# **SUBMISSION ON DEVELOPMENT APPLICATION FOR “SYDNEY MODERN”**

December 2017

ANDREW ANDERSONS AO ARCHITECT . M.ARCH.YALE.F.A.I.A  
T.612 9380 5867 M.61 427 609 907 E.andrewpaddo@gmail.com  
10 ALEXANDER STREET PADDINGTON NSW 2021 AUSTRALIA  
NSW Architects No. 2822 ABN . 37 79 43 67 1 4 3

The diagram on page 11 of the Design Report (annotated as “Diagram from Competition Stage)

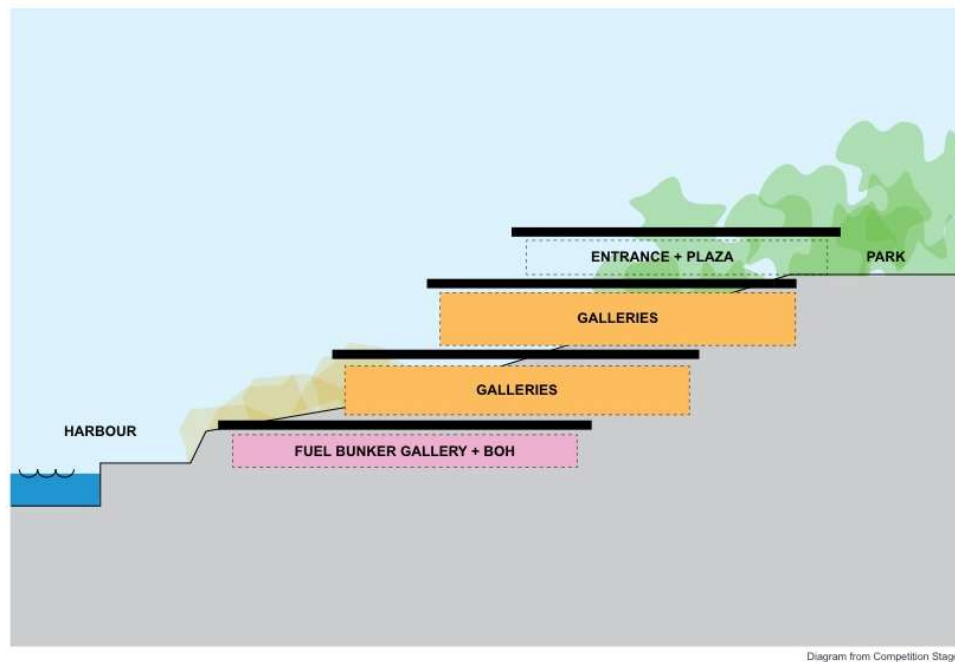
shows outdoor terraces are an extension of interior floor plates of about 25%. Such terraces would be integral to the design concept and can be easily shaded and landscaped.

This seductive diagram belies the reality of the design. Instead of roof terraces being an extension of gallery floor plates they are in fact the tops of adjacent pavilions, creating challenges for shading, landscaping and access.

*The SANAA scheme some months ago. Accessible roof terraces are absolutely minimal and dominated by glary rooftops. The thick overhanging roof-planes appear coarse and the “overlaps” unresolved.*

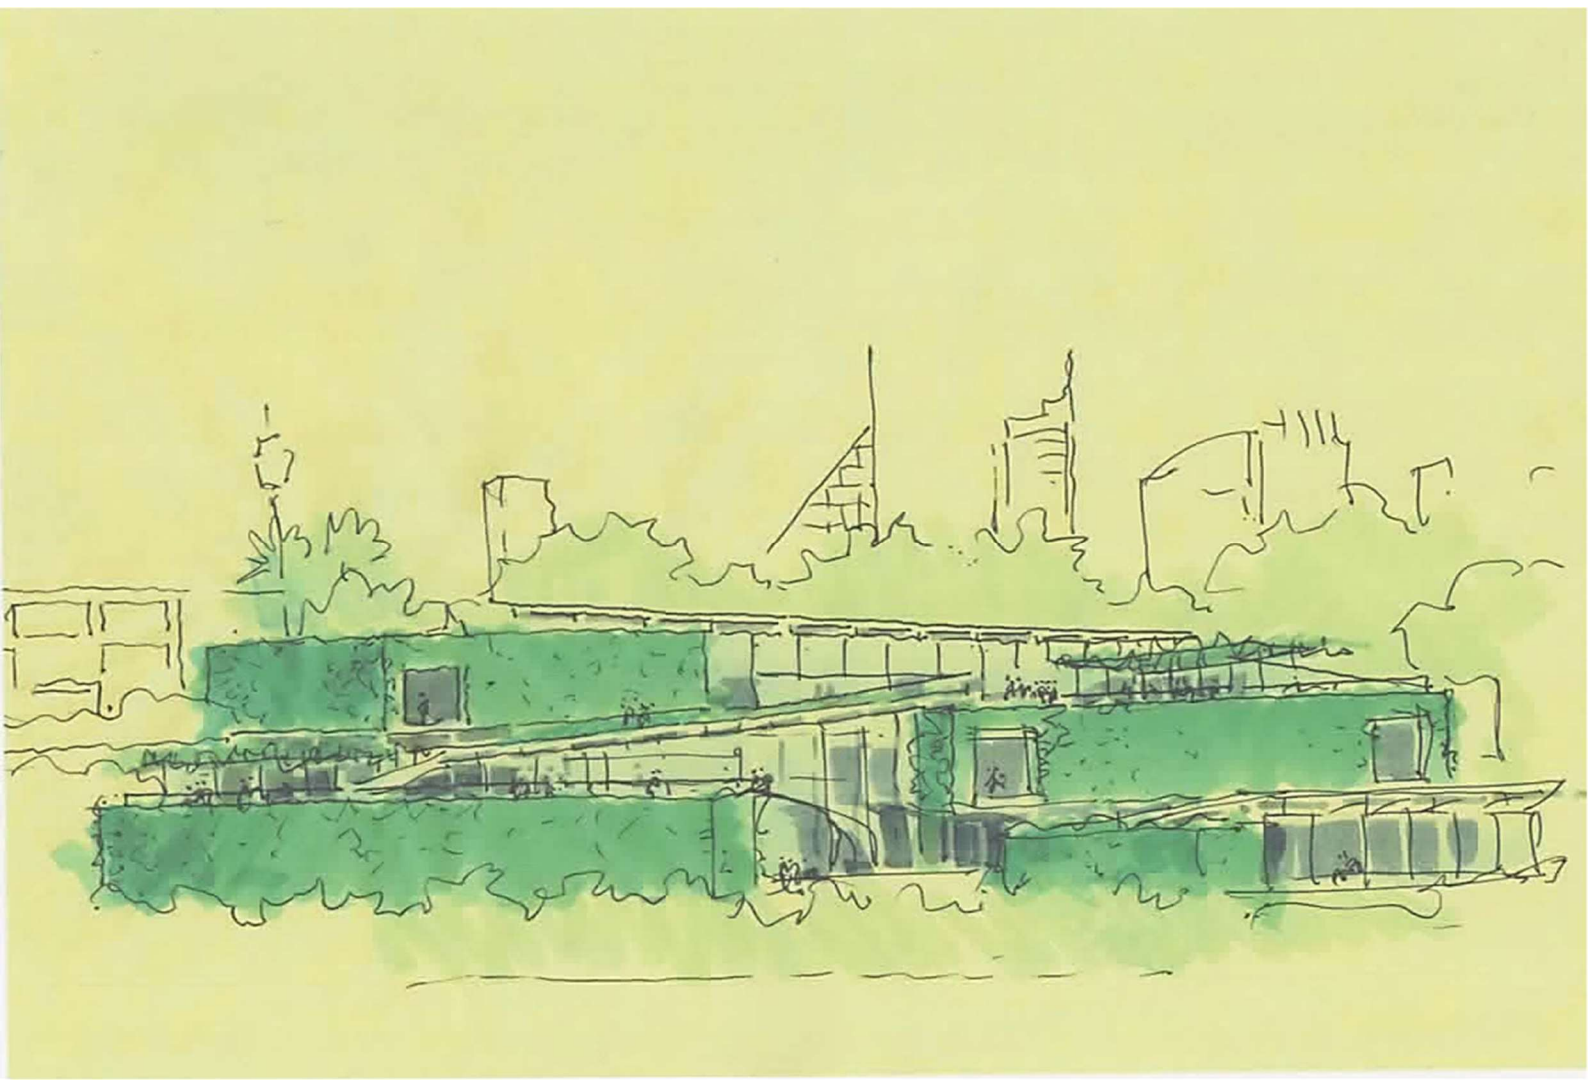
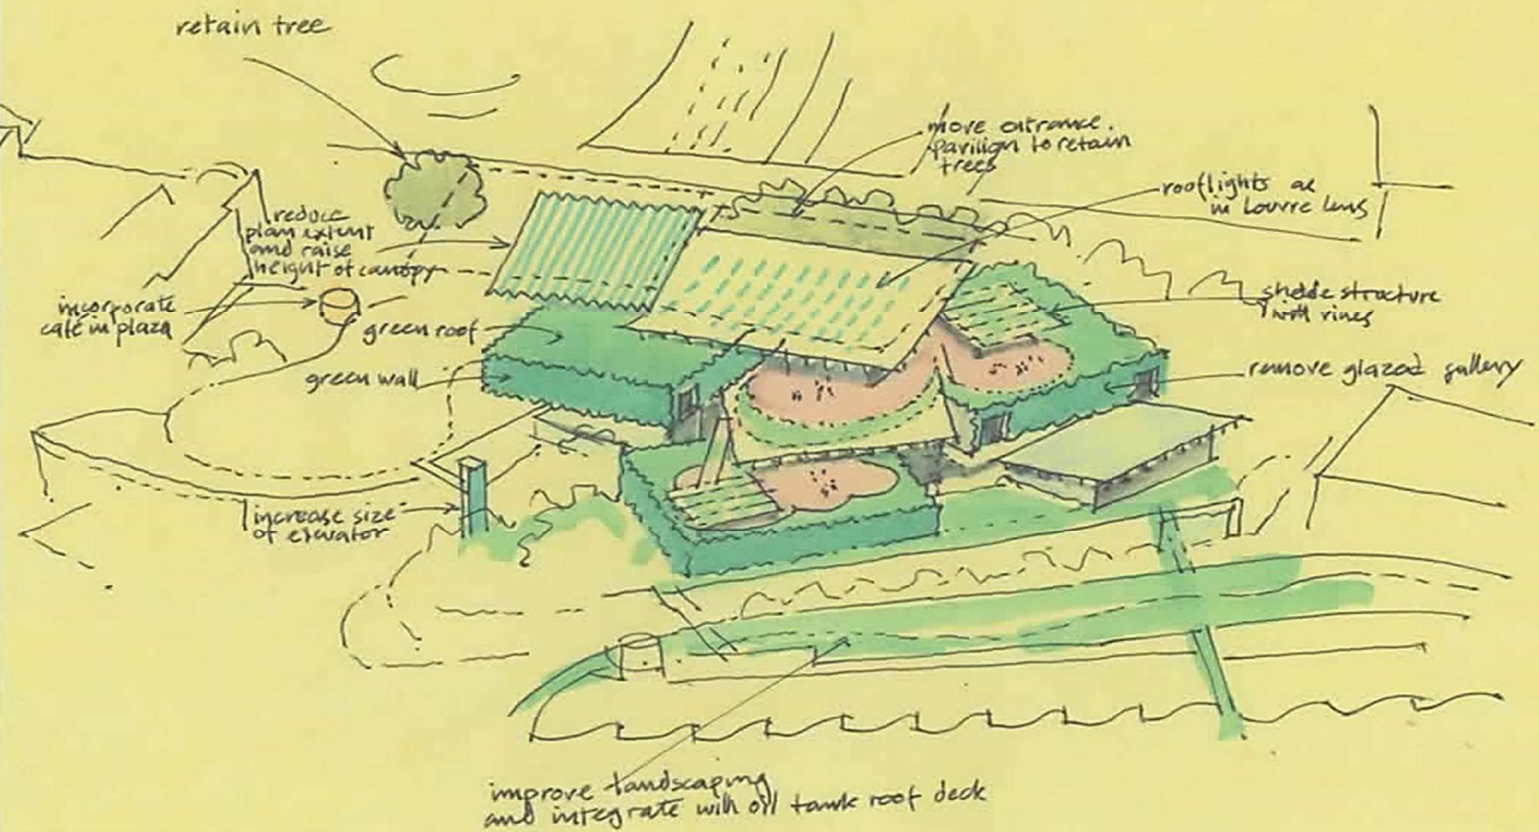
*The current scheme shows significant improvements by removal of the overhangs to the windowless sectors of the building.*

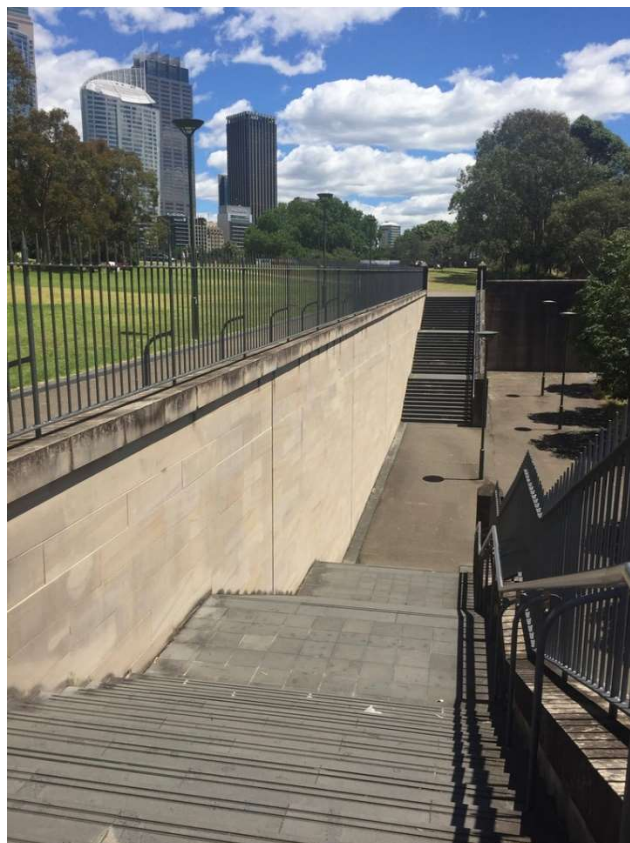
*Current stair from 'land bridge' to Woolloomooloo makes a large statement consistent with significance of link. As half will be demolished there should be some other improvement to compensate. Proposed elevator sales 1.2m square and should be increased.*

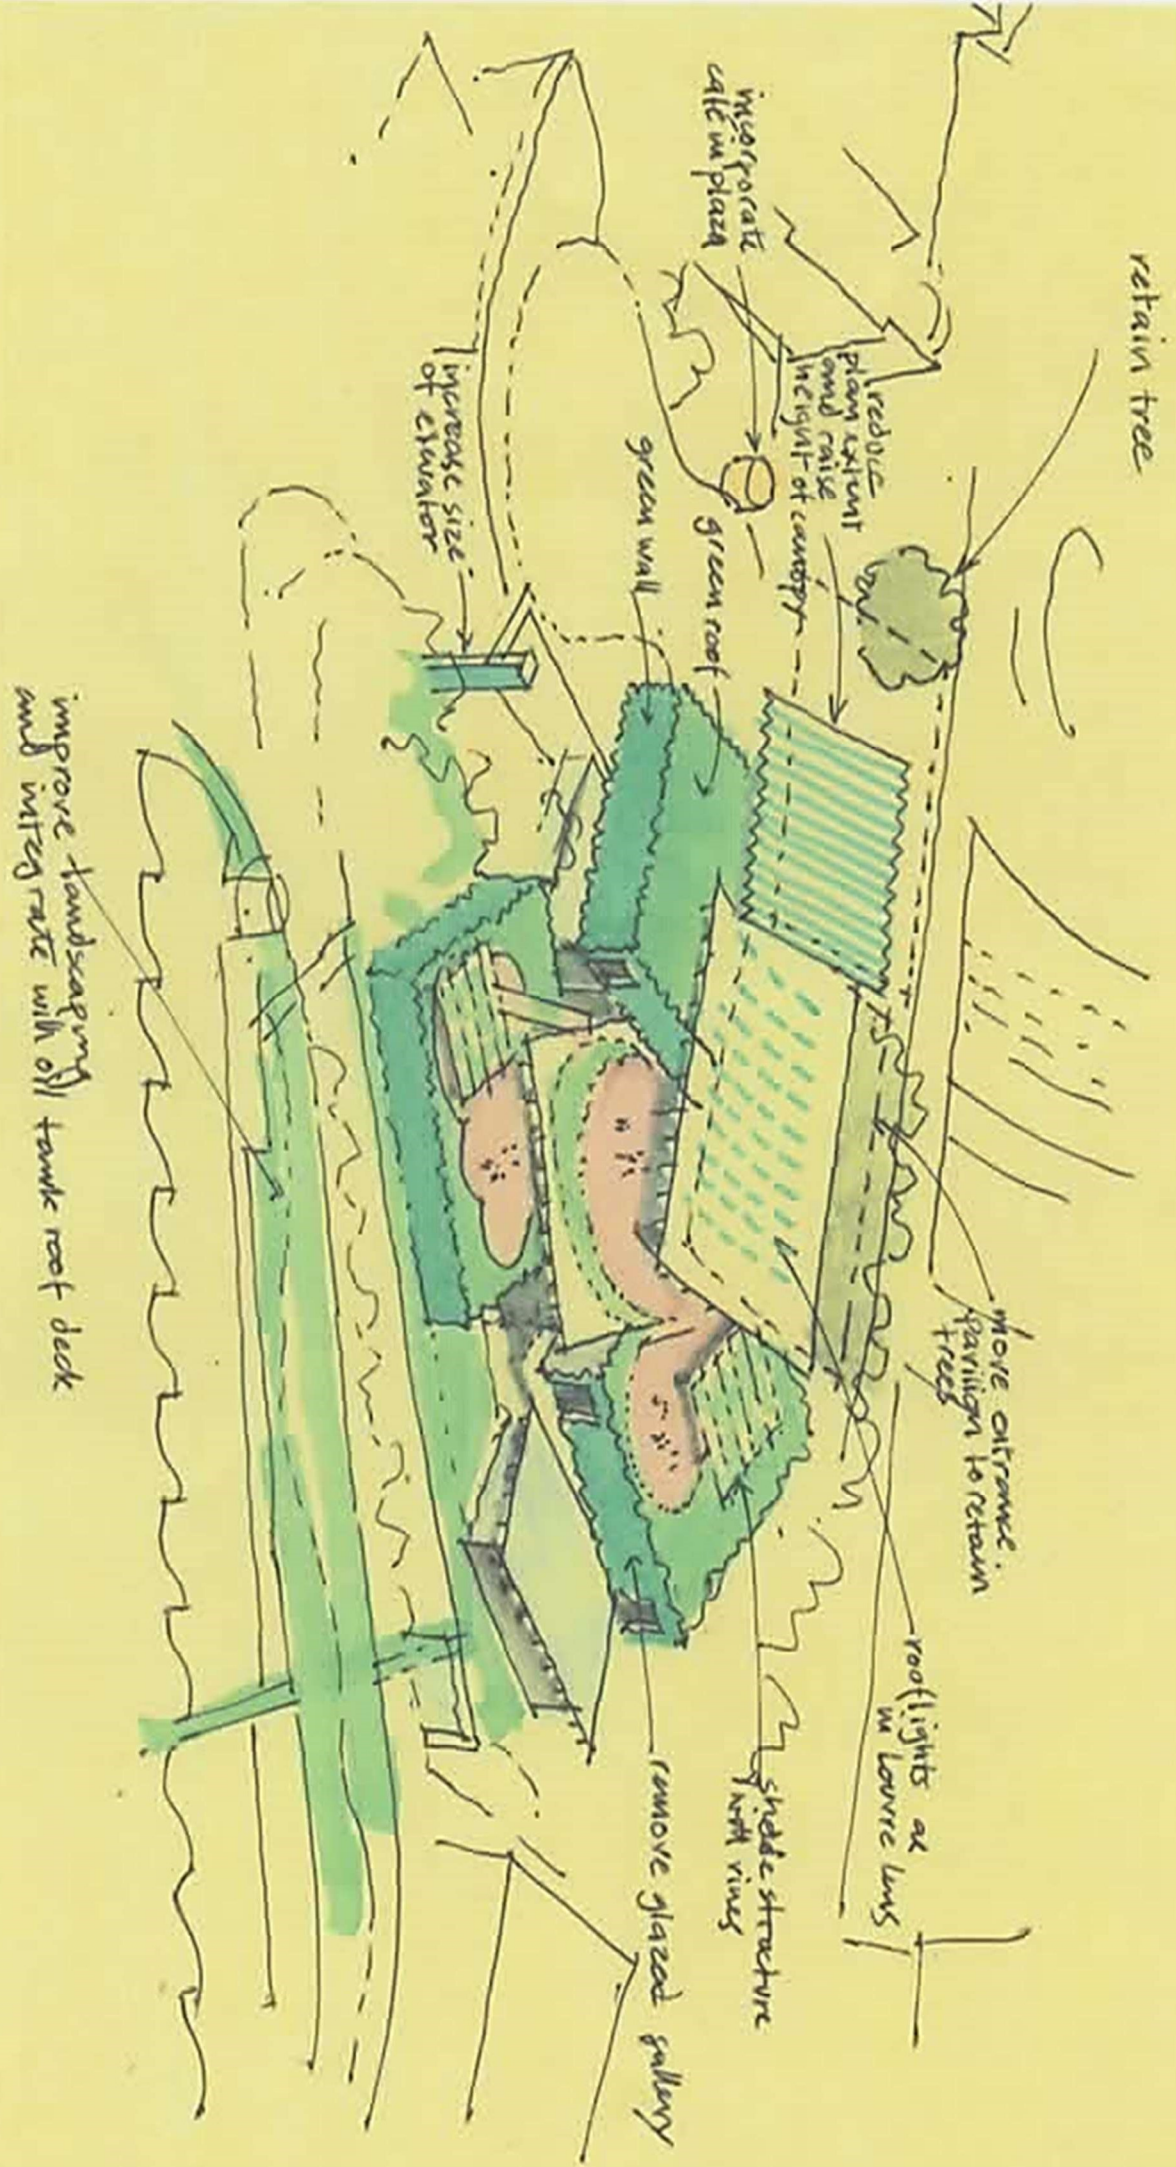
Fig tree should be retained as it enhances space between buildings and provides a buffer between contrasting architectural expression.

Tree frames Henry Moore sculpture.

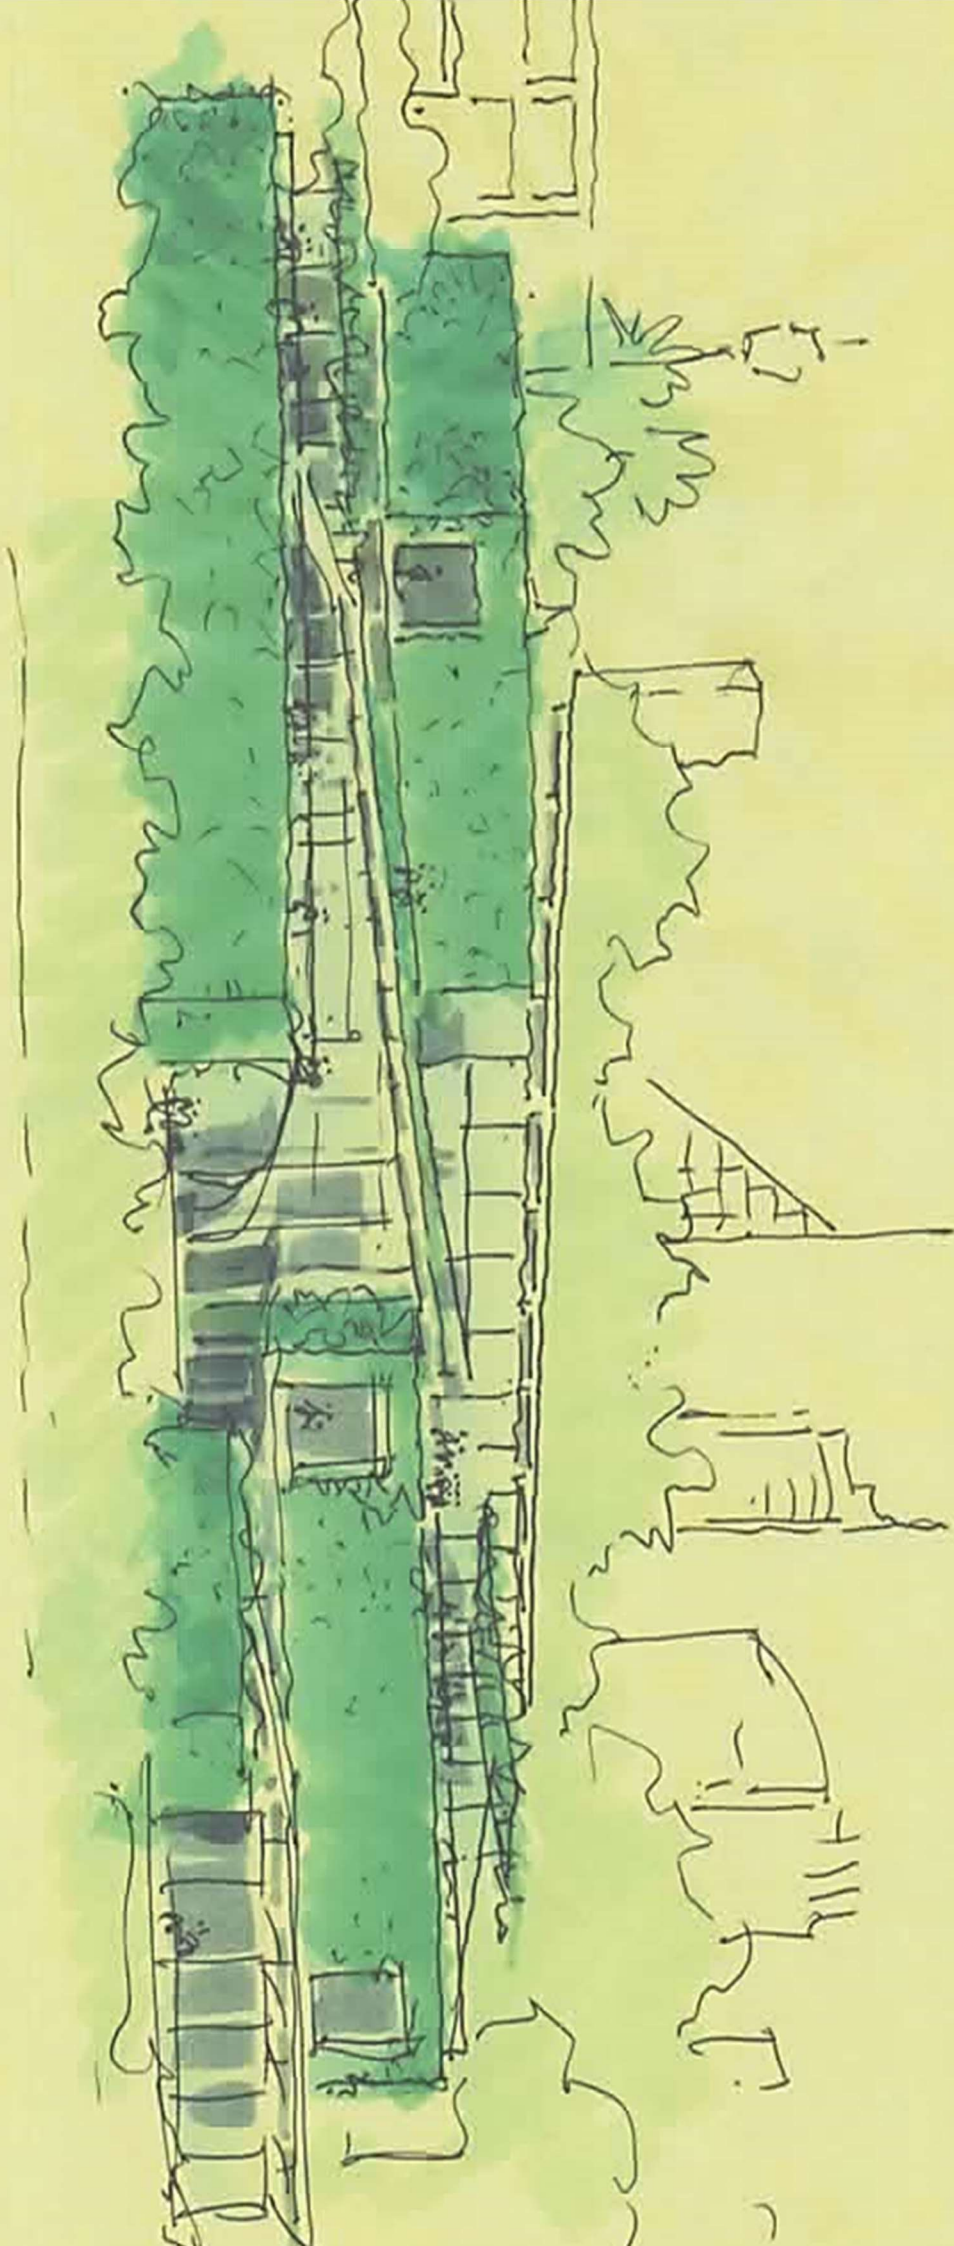
Trees at centre of land-bridge may prove advantageous for positioning sculptures and in case, should be retained until other trees have grown to maturity.

Moving the Entrance Pavilion Eastwards would enable this important buffer of existing trees to be retained.
